Access Compliance Report

Public Rights-of-Way

(Curb Ramps)

Intersection ID: 7018	Main Street: N_GRAHAM_ST	Cross Street: ONEIDA_RD	Location:	E
ADA ID: 4982B089EBCC	Ramp Type: Perp	Initial Pass/Fail: Fail	Overall Compliance: No	Severity Score: 12.5

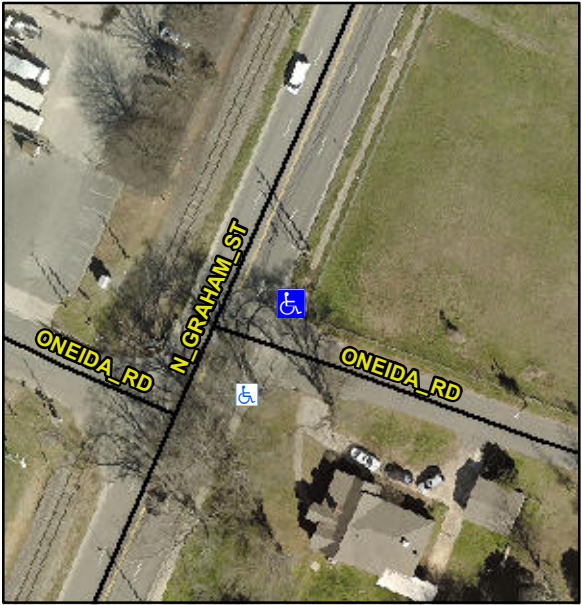
Codes/Mitigation Info/Possible Solution			Field Measurements/Component Compliance		
	Possible Solutions:		Compliance	Description	Data
	Remove & Replace Entire Ramp.		No	Ramp Length (in)	41.0
			Yes	Ramp Width (in)	53.5
			N/A	Flare Type LT	N/A
			N/A	Flare Slope LT (%)	N/A
			N/A	Flare Traversable LT?	N/A
			N/A	Landing Length (in)	N/A
			N/A	Landing Width (in)	N/A
			N/A	Landing Slope (%)	N/A
			N/A	Landing X Slope (%)	N/A
<p>Surveyor Notes:</p> <p>N/A</p> <p>PROW/ADA:</p> <p>Not Found, R304.2.2</p>			N/A	Flare Type RT	N/A
			N/A	Flare Slope RT (%)	N/A
			N/A	Flare Traversable RT?	N/A
			N/A	DWS Provided?	N/A
			N/A	DWS Contrast?	N/A
			N/A	DWS Length (in)	N/A
			N/A	DWS Full Width?	N/A
			N/A	DWS Offset (in)	N/A
			N/A	Gutter Ponding?	N/A
			N/A	Gutter Lip Ht (in)	1.0
			No	Painted X Walk1?	N/A
				X Walk 1 Direction	To SW
			N/A	X Walk 1 Width (in)	N/A
				X Walk 1 Slope (%)	1.4
				X Walk 1 X Slope (%)	3.6
			N/A	Ramp inside XWalk1?	N/A

N/A	Road Slope (%)	N/A
			N/A	Road X Slope (%)	N/A
			N/A	Any Obstructions?	N/A
				Obstruction Type	
Total Cost:		\$ 1850.00	N/A	Clear Space?	N/A
			N/A	Clear Space to XWalk (in)	N/A
			N/A	Storm Grate/Utility Hazard?	N/A
				Storm Grate/Utility Type	
			Yes	Surface Condition? (G/P)	Good
